|  | MODIFICATION BULLETIN Replaces MB 91.6/4 | AIRPL MODEL | 91.6/4B |
| | | 91 Safir | PAGE 1 OF 2 |

Engine Gipsy Major I and X. Replacement of rocker bracket bolts.

FIG. 1

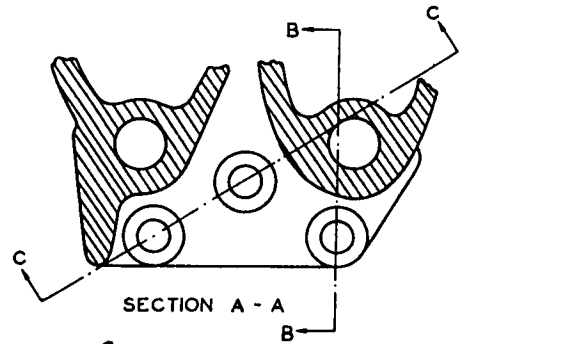
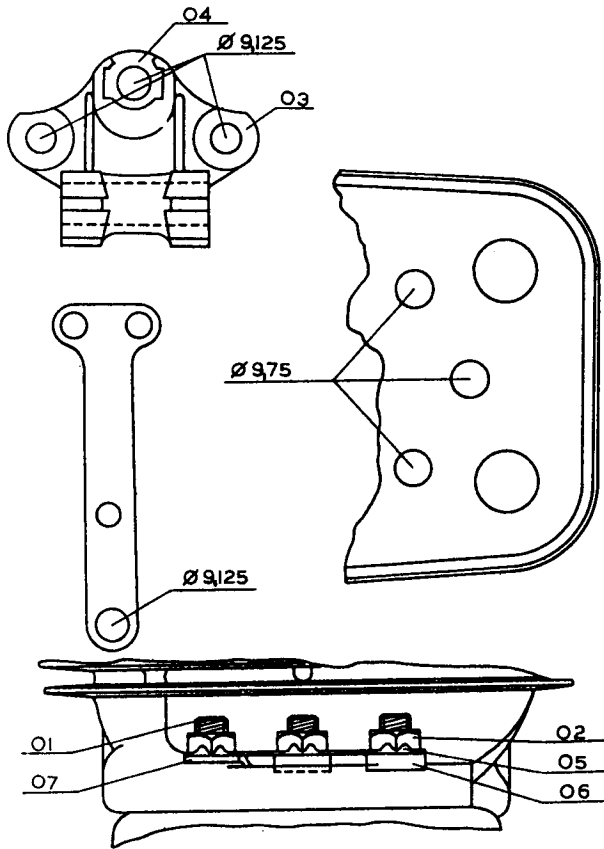
Parts required per each plane equipped with Gipsy Major X engine (Cylinder heads of alumin):

According to the engine manufacturer the nuts for the rocker bracket bolts may be tightened too much in order to be able to fit the cotter pins. Too tight nuts may cause failure of the bolts.

For this reason install new bolts and replace castle nuts and cotter pins with lock plates and tab washers.

Increase the diameter of the three bolt holes located in the cylinder head, valve guide casing and rocker bracket respectively and that of the hole for one of the rocker bracket bolts through the stirrup bracket from 8.125 mm to 9.125 mm.

Install bolts, washers, spacers, lock plates and nuts in accordance with figs 1 and 2 respectively.

Firstly, tighten the nuts enough to pull the unit together without pre-loading the bolts.

Secondly, tighten the nuts $3/12$ of a turn, at a rate of $1/12$ of a turn at a time.

Unscrew the nuts completely and return to the initial condition. Then tighten the nuts $1/6$ of a turn; at a rate of $1/12$ of a turn at a time.

It has been found that by using this method the approx. torque, during the final tightening of the nut will be approx. 300 inlb.

The tab washer under the bolt head should be located as shown in the figure.

FIG. 2

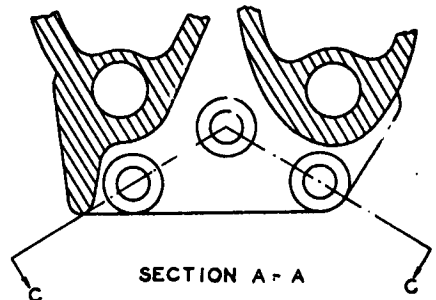
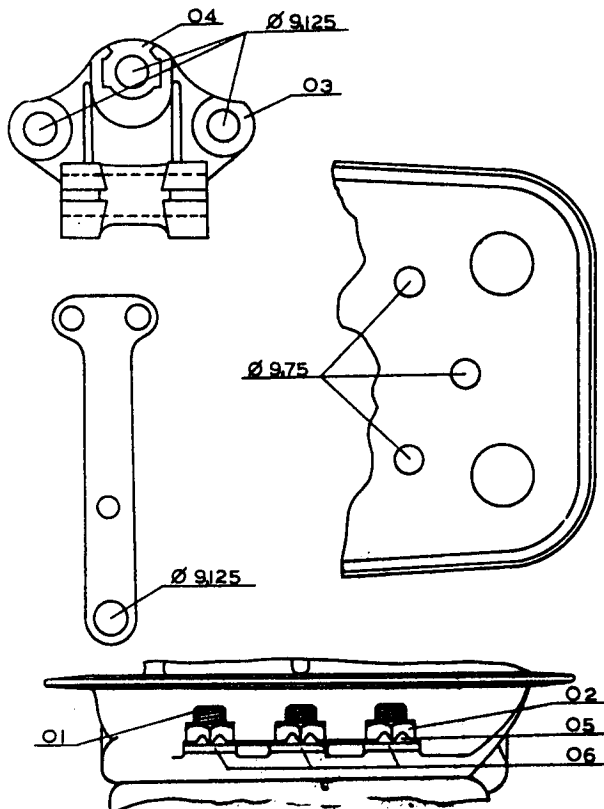
Parts required per each plane equipped with Gipsy Major I engine. (Cylinder heads of bronze):
